John Grace Arms
21030 Indian St, Southfield MI 48033
Developed by
John Grace Arms LDHA LLC

SHEET TITLE
**FIRST FLOOR -
SANITARY, VENTING
AND STORM WATER
PLAN**

ISSUED FOR	DATE
PERMIT	10.20.24
△ BULLETIN 3	05.19.25
△ BULLETIN 4	07.01.25

A6 1B UNIT A - 1ST FLR SANITARY/VENTING PLAN

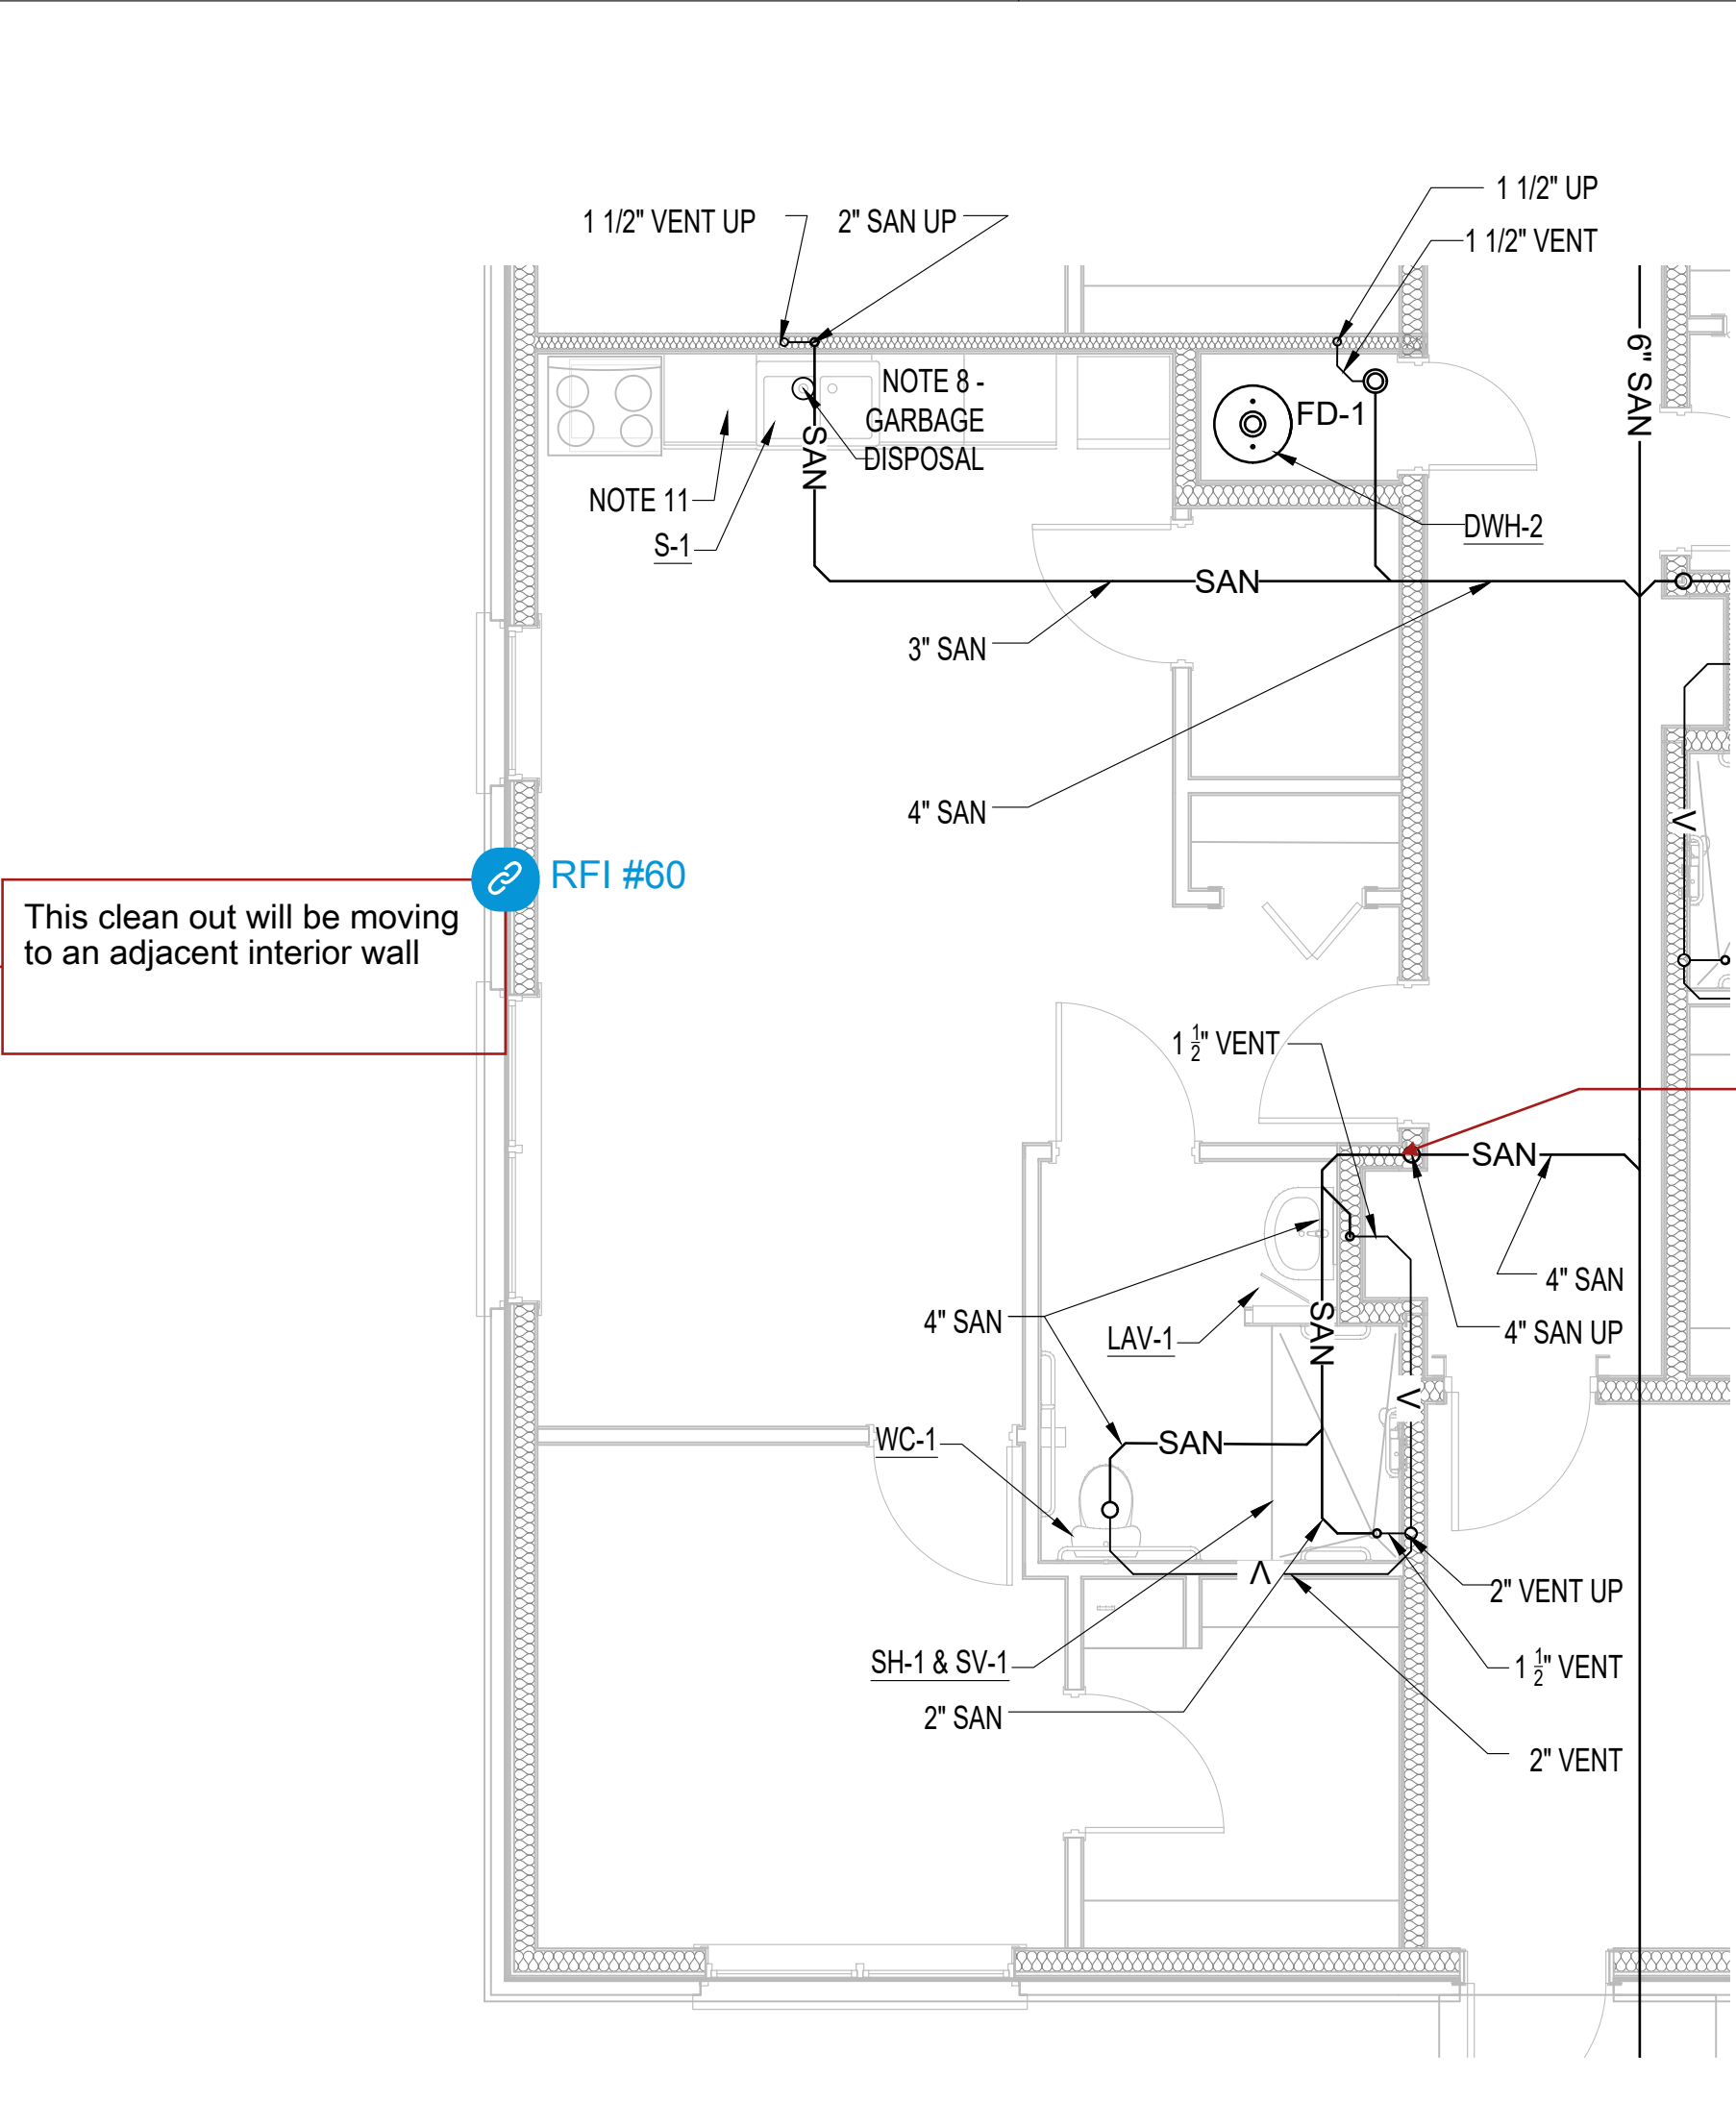
This clean out will be moving to an adjacent interior wall

RFI #60

A12 1B UNIT A - PLUMBING PLAN

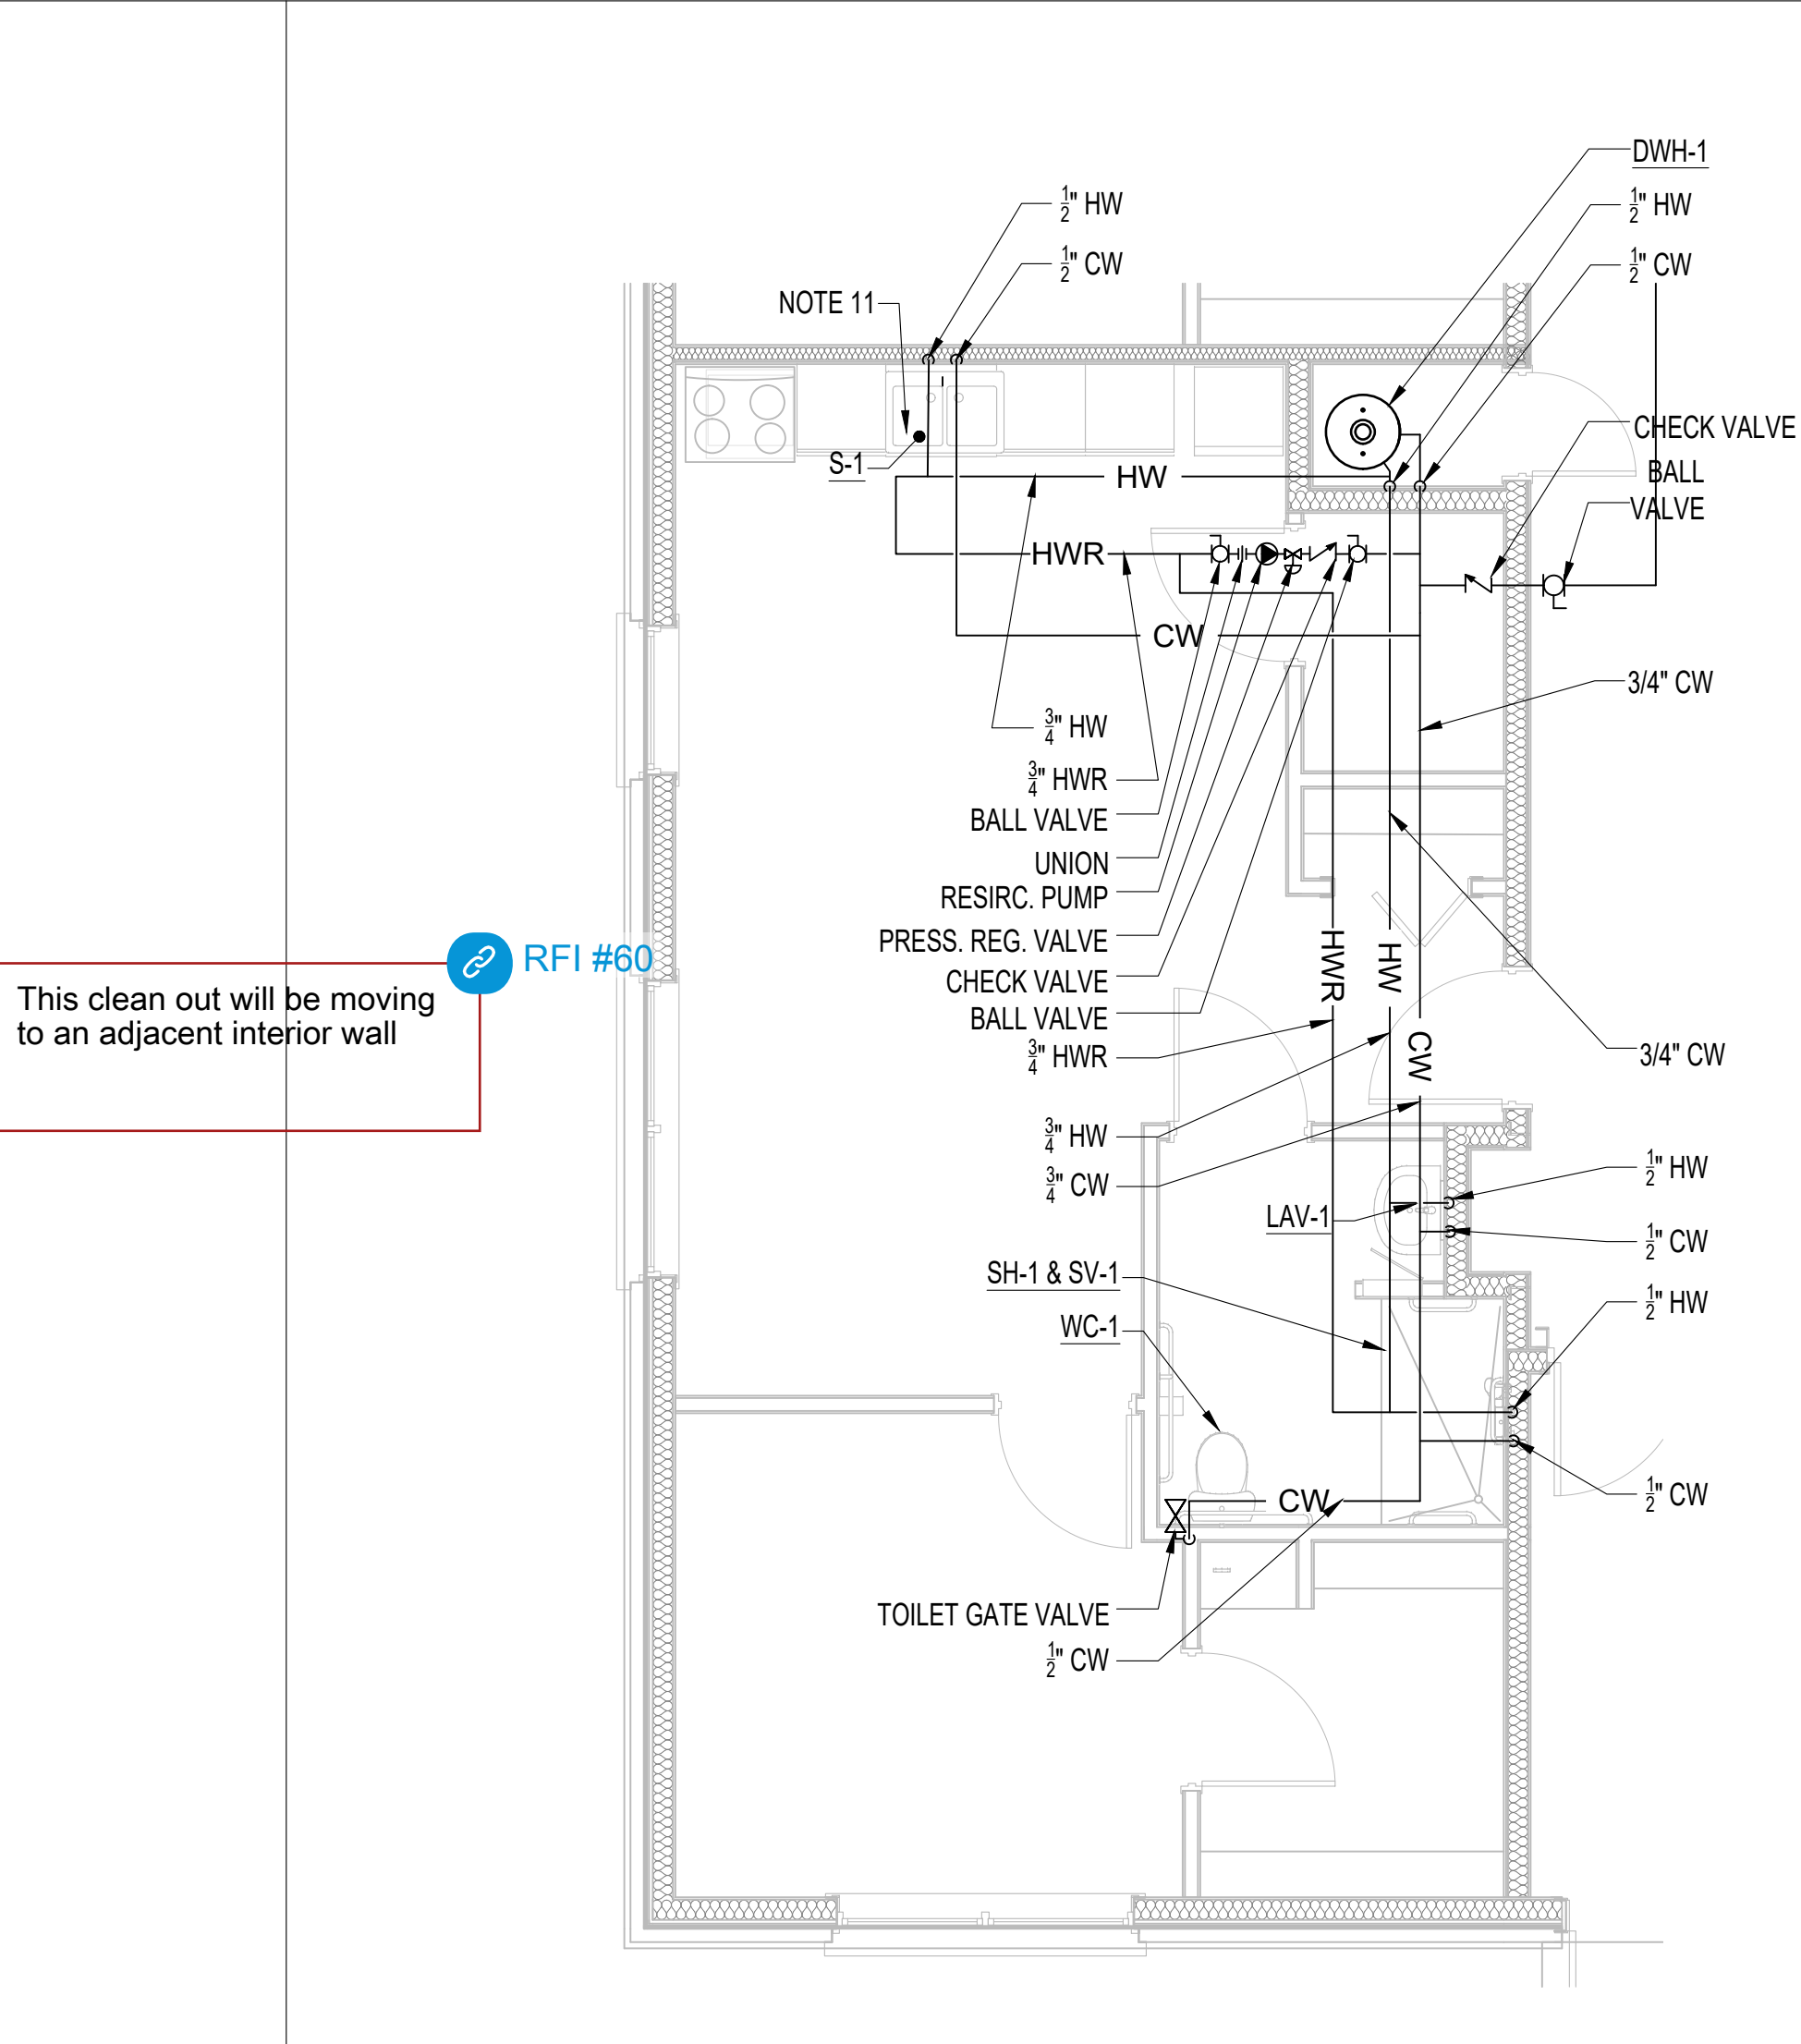
This clean out will be moving to an adjacent interior wall

RFI #60
